Wisconsin Department of Transportation

Proposal #09: 1229-04-76, WISC 2022007
I-43 North South Freeway
Highland Rd to STH 60
IH 43
Ozaukee County

This is Addendum No. 02, which provides for the following:

ADDENDUM NO. 02

Addendum No. 02
 ID 1229-04-76
 Revised Sheet 12
 November 1, 2021

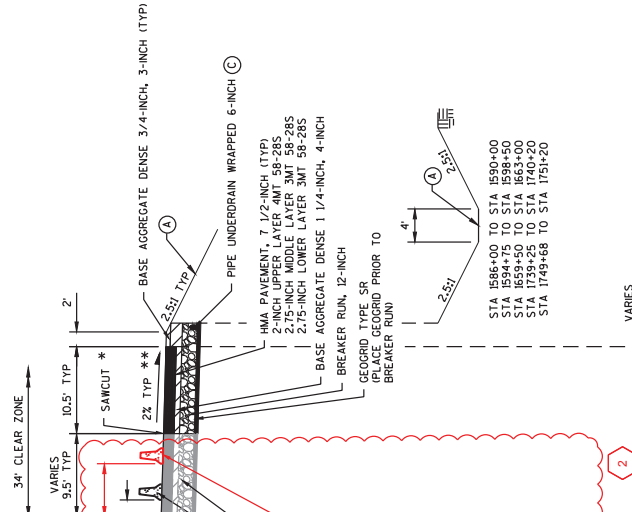
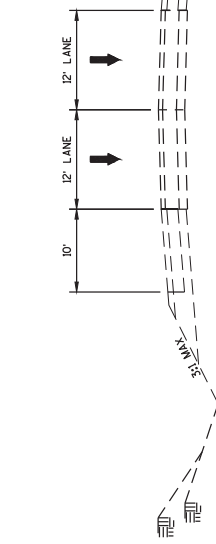
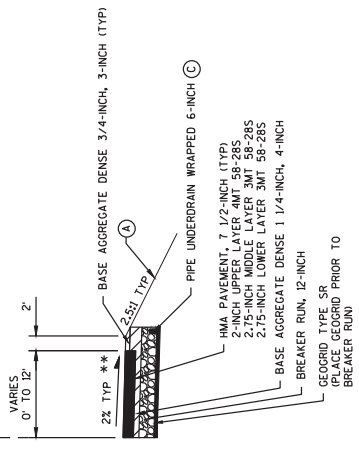
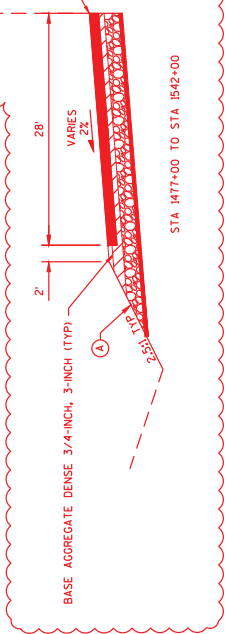
Revised Plan Sheets	
Plan Sheet	Plan Sheet Title (brief description of changes to sheet)
12	Typical Finished Sections (Inside dropdown moved to Stage 1B)
13	Typical Finished Sections (Inside dropdown moved from Stage 1A, temp barrier locations shown)
16	Typical Finished Sections (Added tie bar locations)
41	Construction Details (Revised notes and inset detail, added detail for approach slab concrete barrier)
93	Removal Plan – Legend (Update to General Notes)
486	Temporary Drainage Plan Stages 1 & 2 (Moved temporary inlets)
492	Temporary Drainage Plan Stage 3 (Removed temporary inlet)
493	Temporary Drainage Plan Stage 3 (Removed temporary inlet)

Addendum No. 02
ID 1229-04-76
New Sheet 52A
November 1, 2021

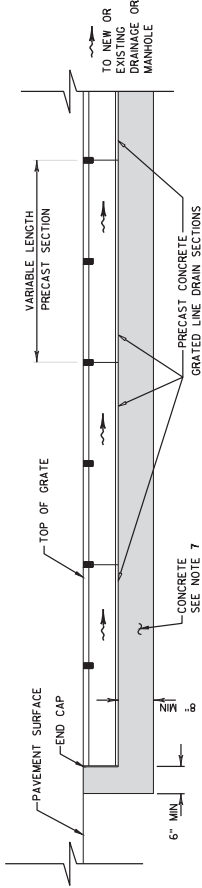
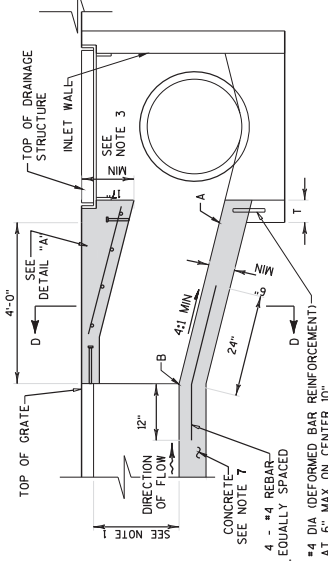
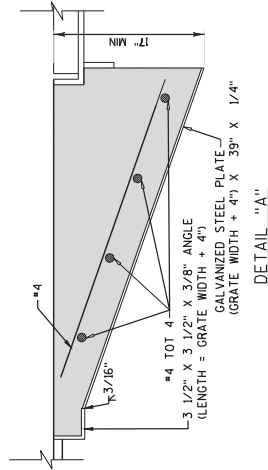
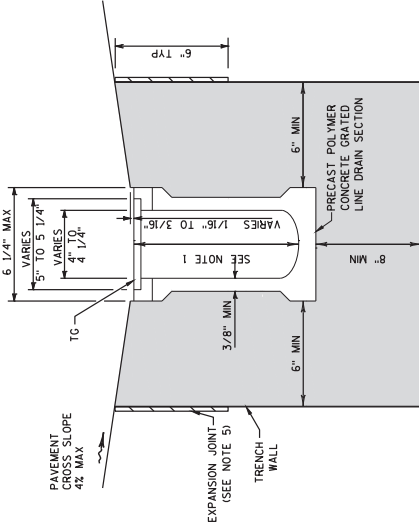
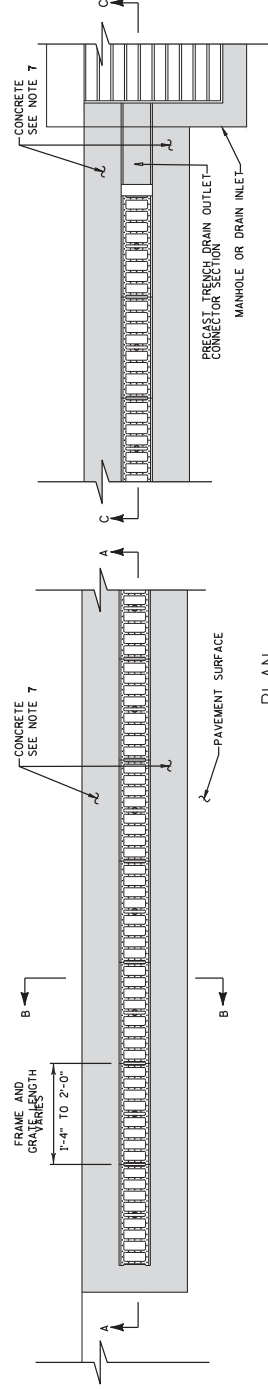
Added Plan Sheets	
Plan Sheet	Plan Sheet Title (brief description)
45A	Construction Details (Underdrain Detail)
52A	Construction Details (Trench Drain Detail)
1045A	Detour – IH 43 NB – Highland Rd Bridge Work (New detour route for use in full freeway closure)
1045B	Detour – IH 43 SB – Highland Rd Bridge Work (New detour route for use in full freeway closure)
1045C	Detour – IH 43 NB – Falls Rd Bridge Work (New detour route for use in full freeway closure)
1045D	Detour – IH 43 SB – Falls Rd Bridge Work (New detour route for use in full freeway closure)
1045E	Detour – IH 43 NB – CTH C Bridge Work (New detour route for use in full freeway closure)
1045F	Detour – IH 43 SB – CTH C Bridge Work (New detour route for use in full freeway closure)
1100A	Miscellaneous Quantities (Storm sewer pipe removals for temporary inlets)

Addendum No. 02
ID 1229-04-76
Revised Sheet 529
November 1, 2021

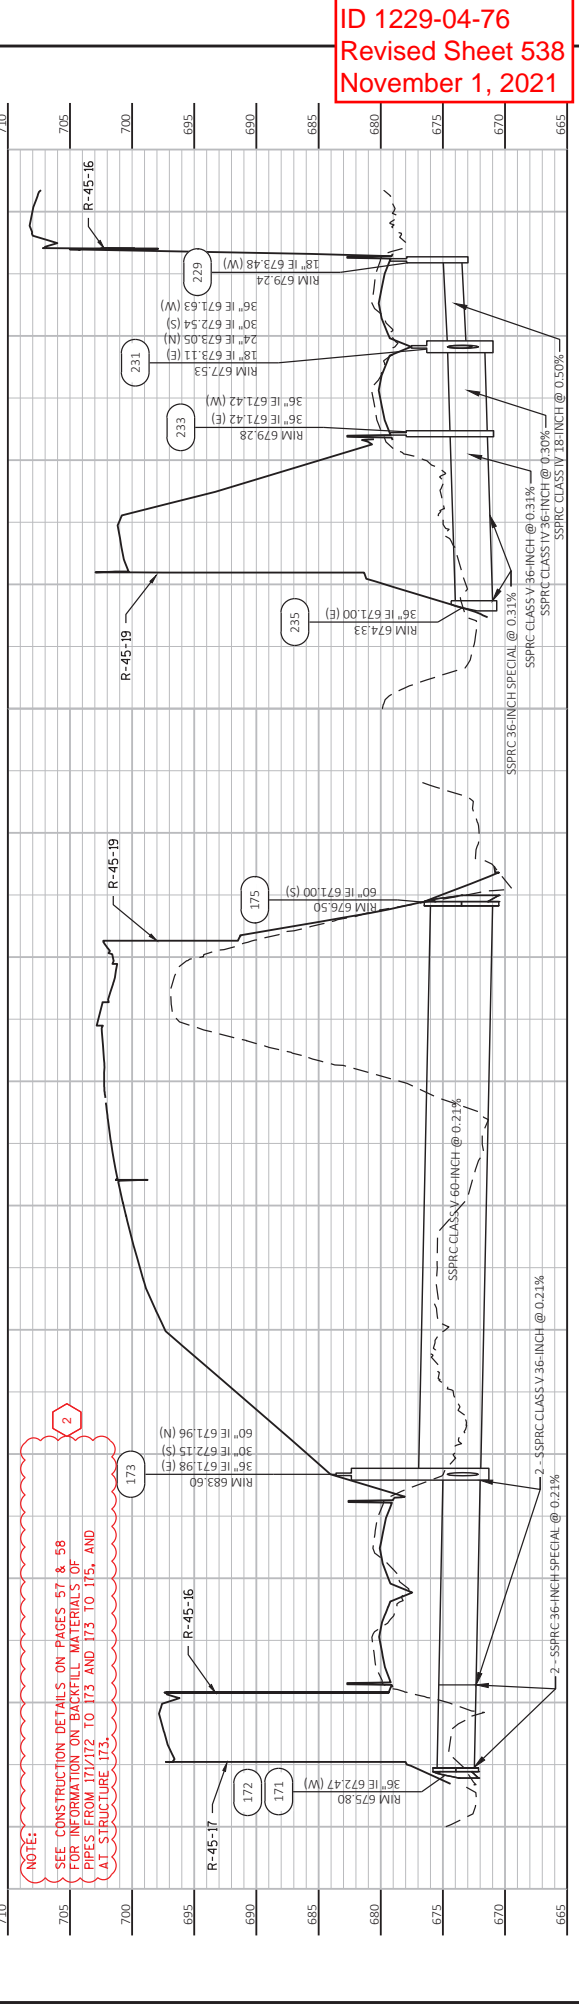
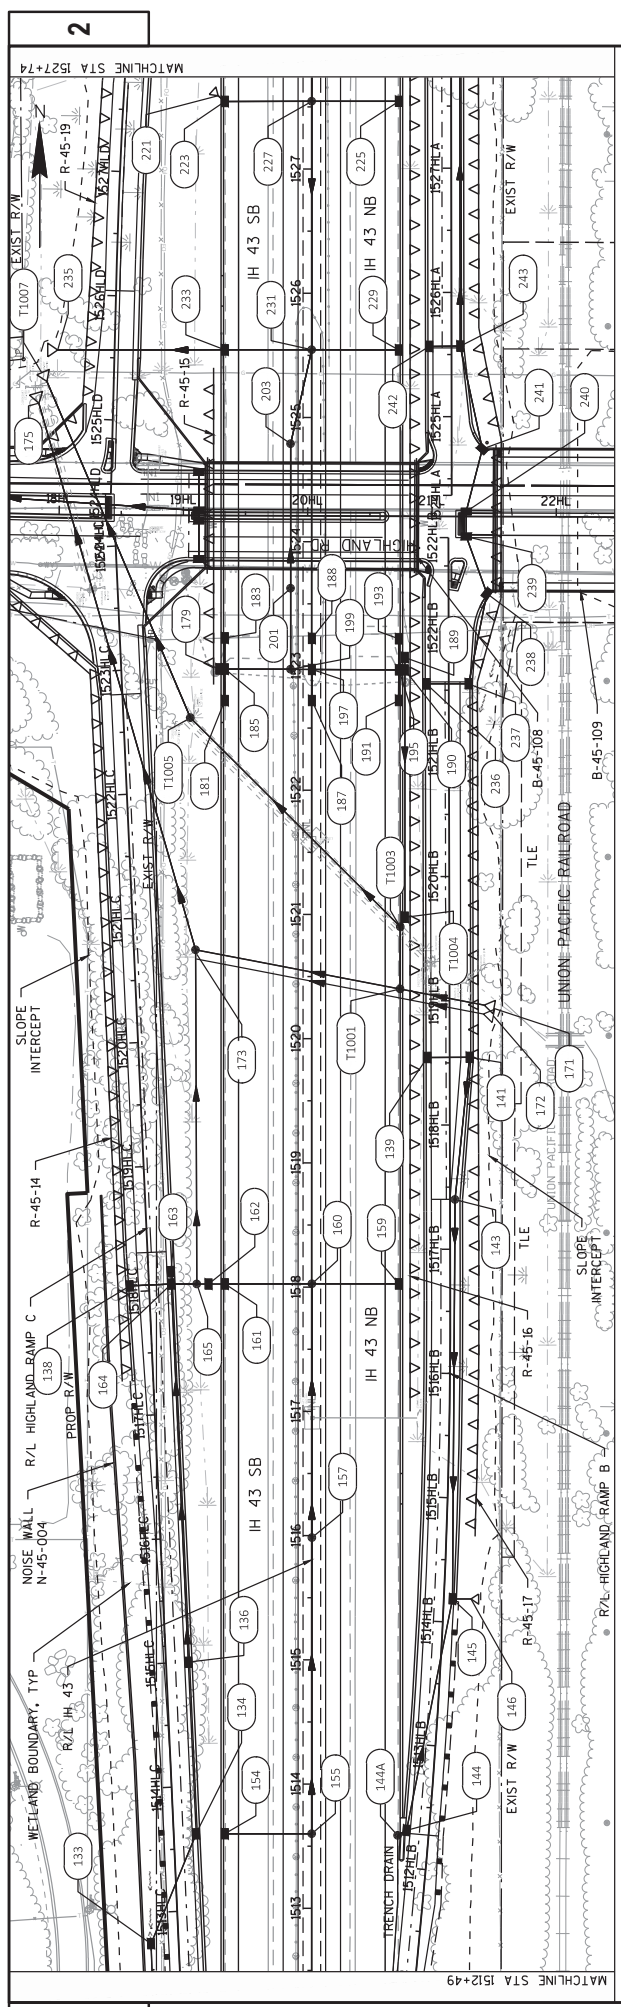
529	Proposed Drainage Staging Plan – IH 43 (Revised staging of median outfall)
538	Proposed Drainage Plan (Added new note)
572	Proposed Drainage Plan (Revised invert elevations of median outfall)
1099	Miscellaneous Quantities: Changed station of Removing Inlet
1102	Miscellaneous Quantities: Added Backfill Controlled Low Strength for large pipe crossing at Highland Interchange, added note about difference between Abandoning Sewer and Backfill Controlled Low Strength
1104	Miscellaneous Quantities (Updated 'Removing Drain Tile' and 'Cold Patch' items)
1105	Miscellaneous Quantities (Updated 'Earthwork Summary' table)
1108	Miscellaneous Quantities (Removed 371.2000.S Table)
1112	Miscellaneous Quantities: Changed offset of Concrete Collar for Pipe, removed three Cover Plates Temporary
1113	Miscellaneous Quantities: Changed station of two culvert extensions
1114	Miscellaneous Quantities: Changed station of two temporary inlets, deleted two temporary inlets
